SERVICE LETTER NO. 72-3

DATE August 7, 1972

SUBJECTS: ITEM 1. STEP DRAIN HOLE MODIFICATION  
ITEM 2. FLAP POSITION INDICATOR MODIFICATION  
ITEM 3. AILERON BALANCE WEIGHT ARM MODIFICATION  
ITEM 4. CANOPY LATCH AND LOCK SEALING IMPROVEMENTS  
ITEM 5. CANOPY TRACK TEFLON RUNNER ROLL PINS  
ITEM 6. REAR SEAT CLOSE OUT COVERS  
ITEM 7. TAIL TIE DOWN RINGS

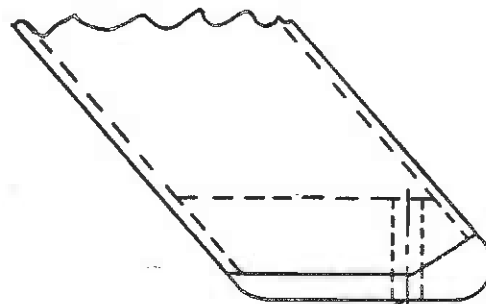
On production aircraft, AA5-0027 and up, the optional outside steps have been redesigned to include 3/16" diameter drain holes through the bottom caps to prevent an accumulation of moisture inside the steps. Aircraft prior to AA5-0027, which are equipped with the optional outside steps, should have these drain holes added. See Figure 1 below for the proper location of these holes.

Drill 3/16" dia. thru.

.85 ±.06

Canopy Lock and Latch Sealing Improvements

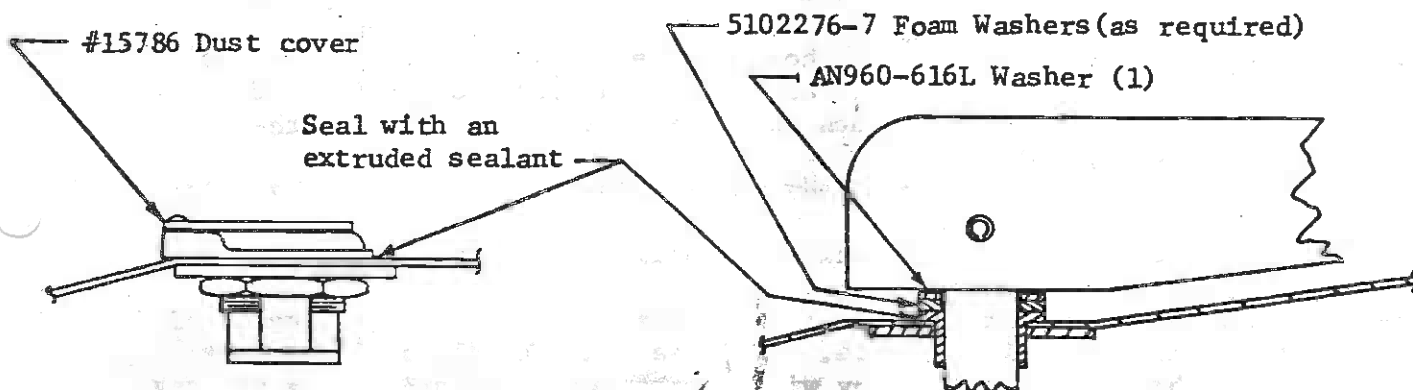
Changes have been incorporated on recent production aircraft to improve sealing in the canopy latch area. The faying surface of the canopy latch handle shaft nyliner bearing is sealed to the canopy with an extruded sealant\* when the bearing is installed. One AN960-616L washer(directly under the latch handle) and foam tape washers, Part No. 5102276-7 are installed, as required to fill the gap between the outside canopy latch handle and the canopy top skin to seal the latch handle shaft where it passes through the canopy skin. Additionally the canopy lock body is sealed to the canopy with an extruded sealant and a dust cover is now used over the key slot. These improvements can be made on earlier model aircraft as follows:

1. Remove the canopy handle and the shaft nyliner bearing.
2. Remove the royalite trim panel covering the canopy latch box assembly inside the canopy.
3. Remove all the screws holding the latch box assembly to the canopy and spring the aft end of the box assembly down far enough to allow wrench clearance for the 7/8" nut on the canopy key lock.
4. Remove the key lock body and slip on the dust cover assembly #15786.
5. Reinstall the key lock body sealing it to the canopy with an extruded sealant\*.
6. Reassemble the latch box assembly to the canopy in reverse of the removal procedure. Seal the latch handle shaft nyliner bearing to the canopy with an extruded sealant\* wiping off any excess.
7. Install foam washers(P/N 5102276-7) adhesive side up as required and one AN960-616L washer to fill the gap between the canopy top and the latch handle. Install the handle. See Figure 4A and 4B.

1. Remove the outside canopy latch handle(and any washers underneath it).
2. If the latch handle shaft bearing is not sealed to the canopy remove it, apply extruded sealant\* to the mating surfaces and reinstall it in the canopy.
3. Install foam washers(P/N 5102276-7) adhesive side up as required, and one AN960-616L washer, to fill the gap between the canopy and the handle. Reinstall the latch handle.

Figure 5. Canopy Track Modification.

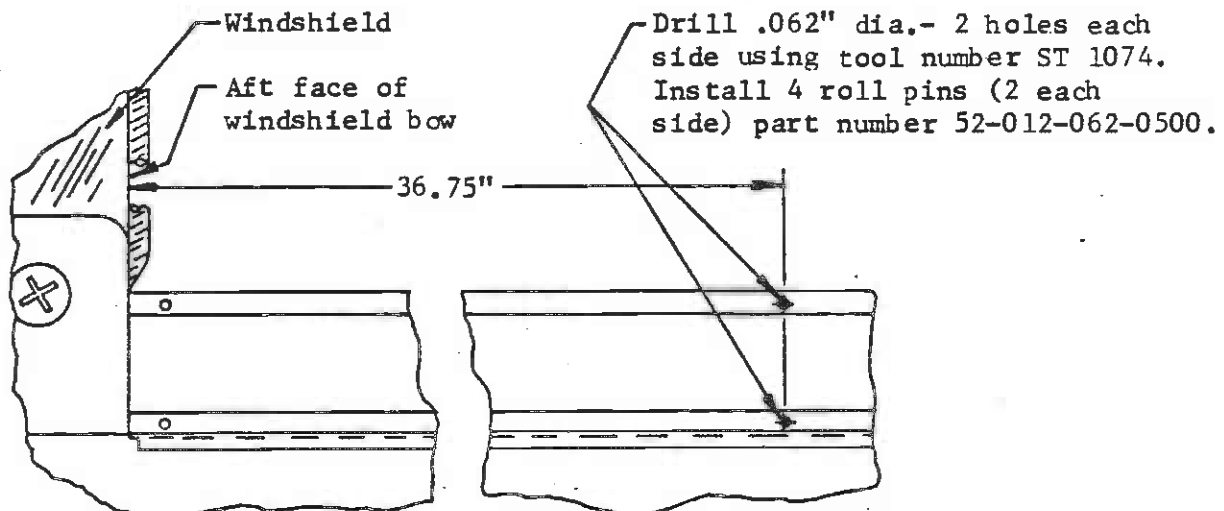
AA5-0146 and on have four additional roll pins installed in the canopy track assembly to provide improved retention of the teflon runners. These roll pins can be installed on aircraft below AA5-0146 by removing the two canopy stops and carefully sliding the canopy aft far enough to insert the canopy track drilling tool #SF-1074 and drill the .062" diameter holes 36.75" from the front of the track, (see Figure 5). The installation of these new roll pins is identical to the existing ones at the front of the track. After the pins are installed slide the canopy forward and replace the canopy stops.

Figure 7. Tail Tie Down Rings.

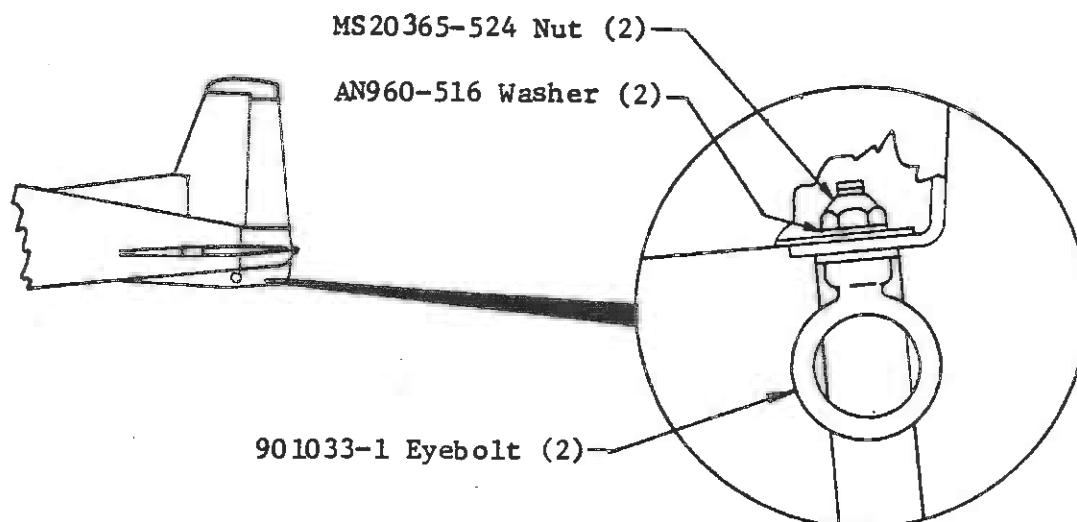
On production aircraft AA5-0047 and up two tail tie down rings (one on each side of the ventral fin) have been added to the bottom of the fuselage below the rear stabilizer bulkhead. These eye bolts can be added to aircraft AA5-0001, through AA5-0046 as follows:

Take off a rear access cover, remove and discard the existing bolts, nuts and washers that attach the ventral support braces, to the bottom of the fuselage. Enlarge the holes in the braces and the corresponding holes in the bottom of the fuselage to 5/16" diameter and install the eyebolts, washers and nuts, (see Figure 7). Prime and paint the eyebolts the aircraft color.
